JAMES A. FITZPATRICK NUCLEAR POWER PLANT

Amendment No. 57
License No. DPR-59

SAFETY EVALUATION BY THE OFFICE OF NUCLEAR REACTOR REGULATION
SUPPORTING AMENDMENT NO. 57 TO FACILITY OPERATING LICENSE NO. DPR-59
POWER AUTHORITY OF THE STATE OF NEW YORK
JAMES A. FITZPATRICK NUCLEAR POWER PLANT
DOCKET NO. 50-333

FIGURE 6.2-1

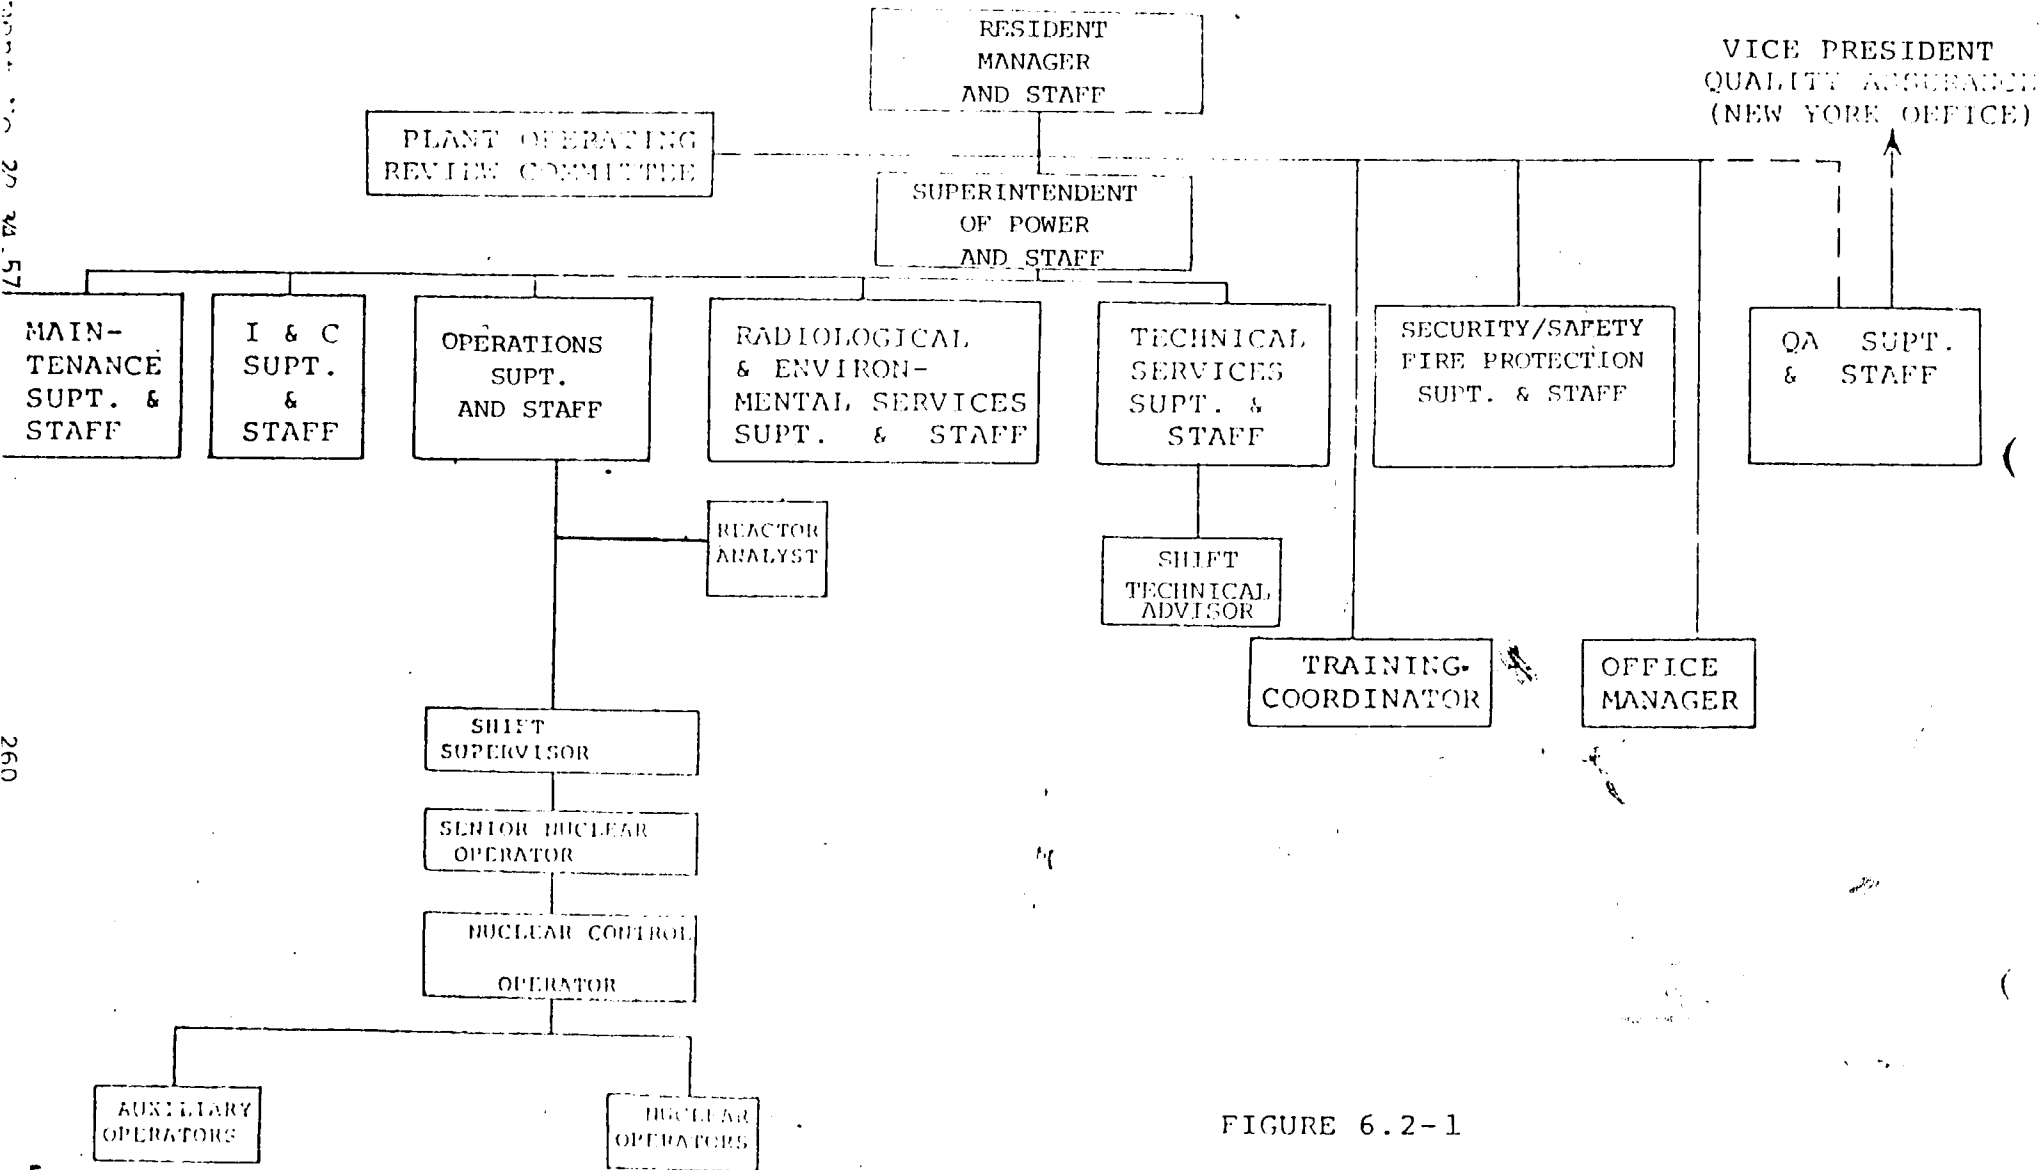
Our request indicated that the TSs related to minimum shift manning should be revised to reflect the augmentation of an STA. The STA function includes both accident and operating experience assessment. The licensee response proposed TS changes which provide for the Shift Technical Advisor. We have reviewed these changes and conclude that the licensee has satisfied this requirement.
